West River Grocery Store Pedestrian & Bike Access Issues

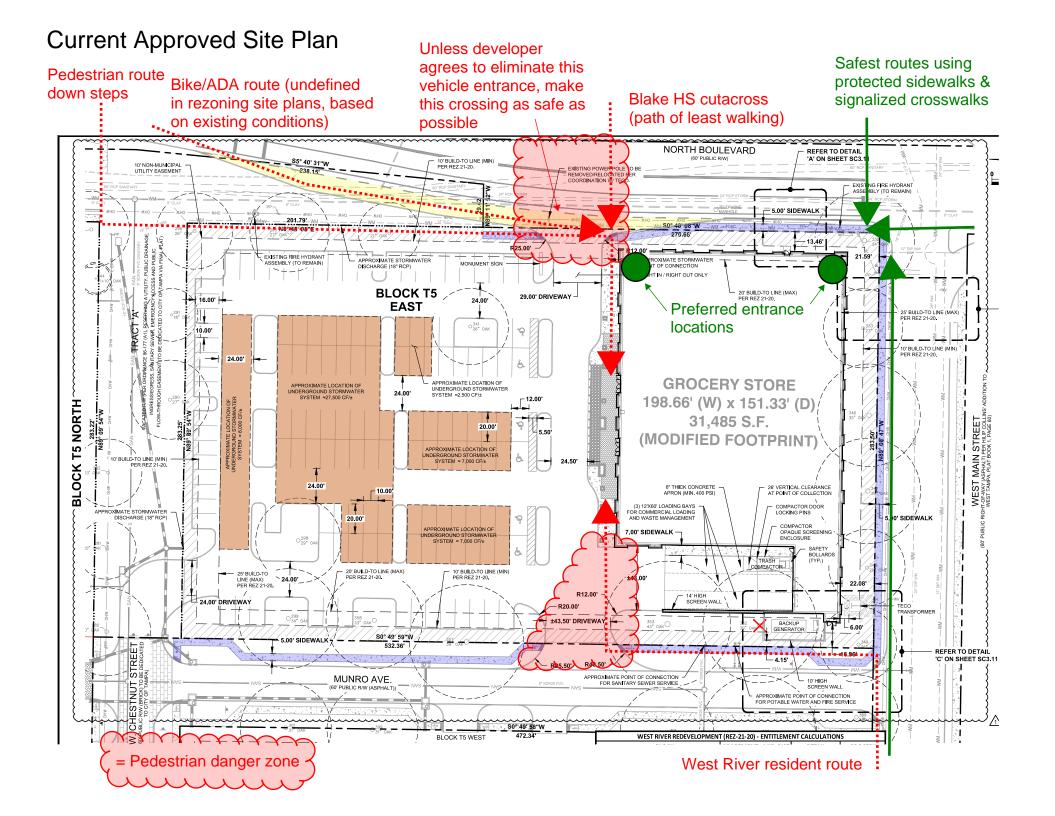
Forcing pedestrians to have to cross vehicle traffic multiple times and enter through a parking lot is dangerous and not a best practice for urban design. Creating building entrances within proximity of protected crosswalks is imperative.

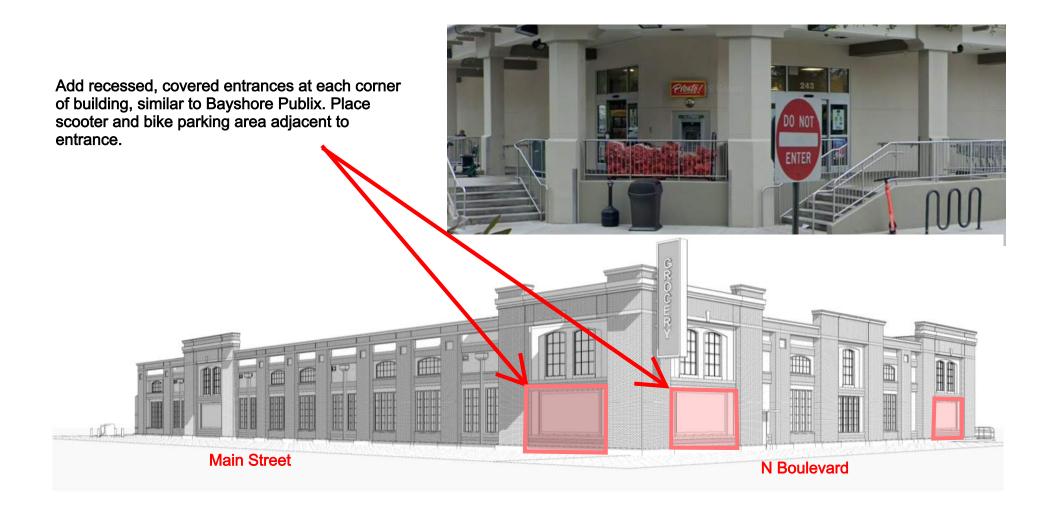
NMU-35 requires "building facades along front build-to-line shall have functioning ground floor entrance. Rear-only facing buildings are prohibited." This design is a dressed-up version of a rear-only facing building.

NMU-35 requires 65% transparency in non-residential facades, this proposed grocery store has Zero % transparency in its windows along Main Street and N Boulevard. This is a well-established pedestrian-deterrent design.

Create recessed covered entry area similar to that on the southeast corner.

Extend portico to corner of building to provide welcoming covered entry. Use covered area for bike/scooter parking.
